## Technical Service BULLETIN

### MULTI-DISPLAY FUNCTIONS ARE INOPERATIVE

'04 Highlander, Land Cruiser & Prius

ELECTRICAL  
EL002-05

**Highlander M3 Wiring Harness Side Connector**

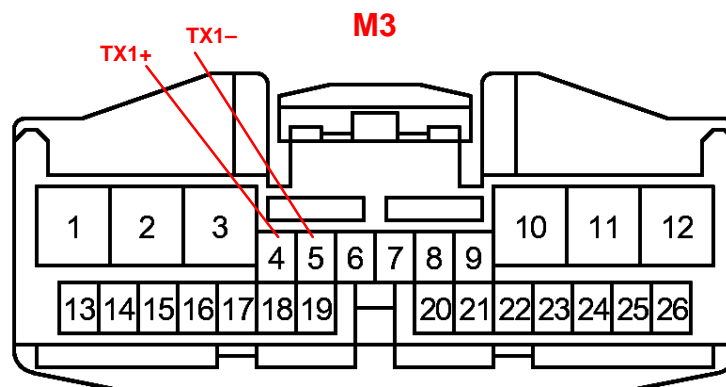
1. Check all the TX terminals on the multi-display connectors (please see connector diagrams) and confirm the terminals are fully seated. Replace any damaged terminals or connectors.
2. Confirm the connectors to the multi-display are fully seated. Replace any damaged connectors.
3. If all the TX terminals are tight and the connectors are fully seated, replace the multi-display.
